ADDENDUM NO. 3 TO PROJECT NO. 44496

**CONSTRUCTION WORK, HVAC WORK AND ELECTRICAL WORK
REPLACE UNDER GROUND HEAT AND WATER LINES
ULSTER CORRECTIONAL FACILITY
750 BERME ROAD
NAPANOCH, NY**

February 7, 2014

SHEET TITLE: REVISION TO DETAIL 3,
BUILDING NO. 50
FIRST FLOOR PLAN

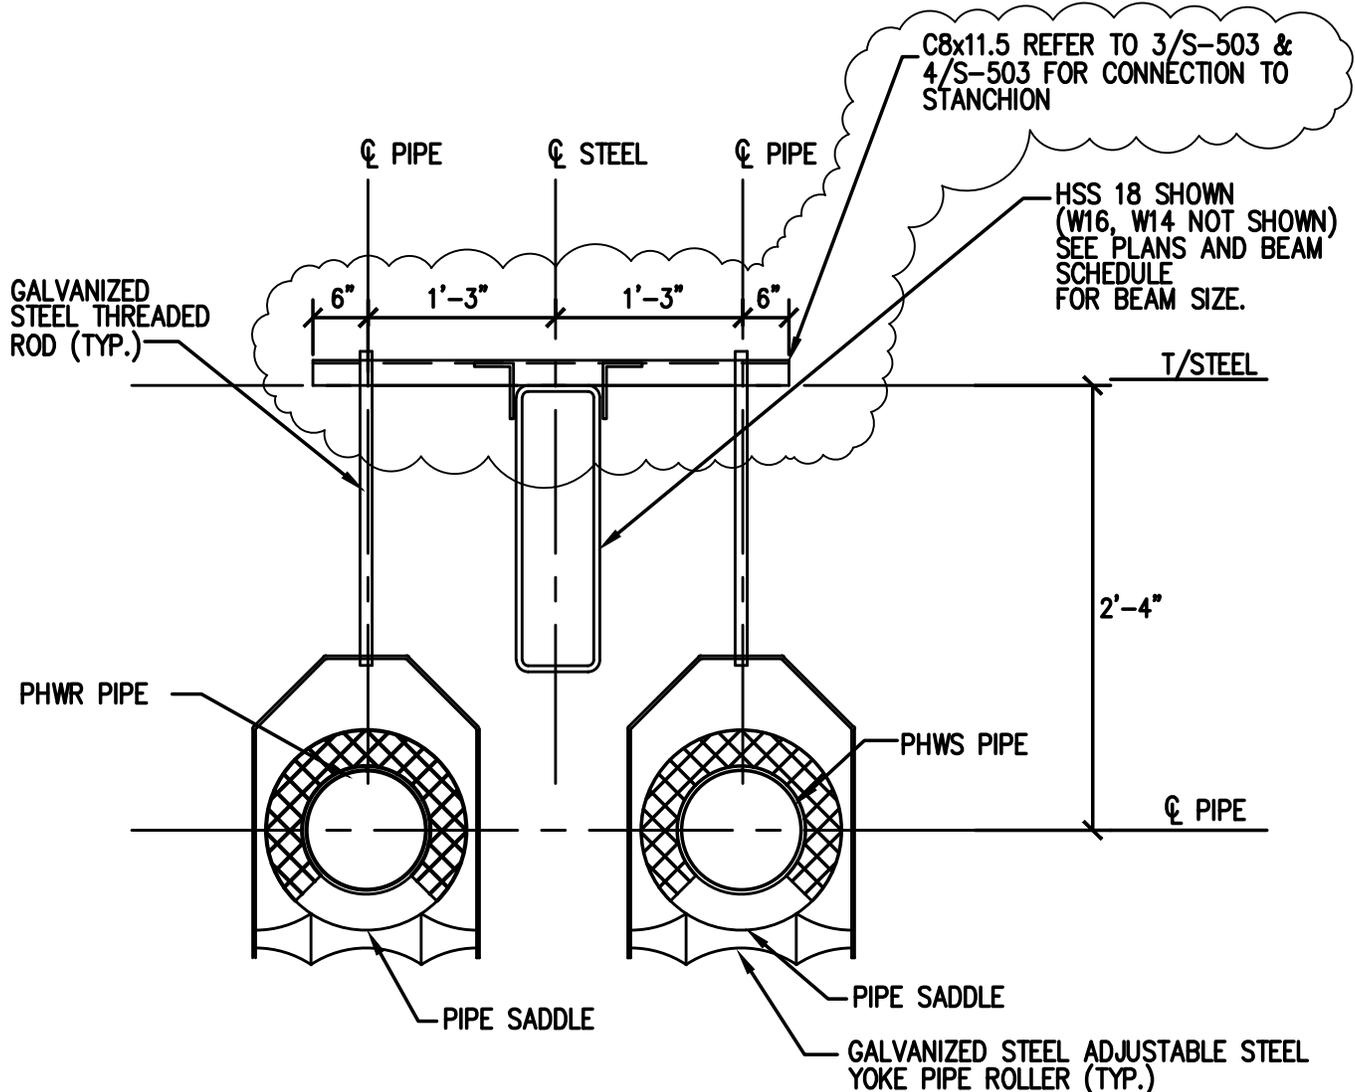
3. Drawing No. M-411, Detail 3: Delete this detail in its entirety. Refer to Addendum Drawing No. M-413 dated 2/4/14 for Revised Detail.
4. Drawing No. S-505, Detail 1: Delete this detail in its entirety. Refer to Addendum Drawing No. S-515 dated 2/4/14 for Revised Detail.
5. **ADDENDUM DRAWINGS:** Drawing No M-413, S-515 noted “Addendum Drawings 2/5/2014” accompanies this addendum and form part of the contract documents.
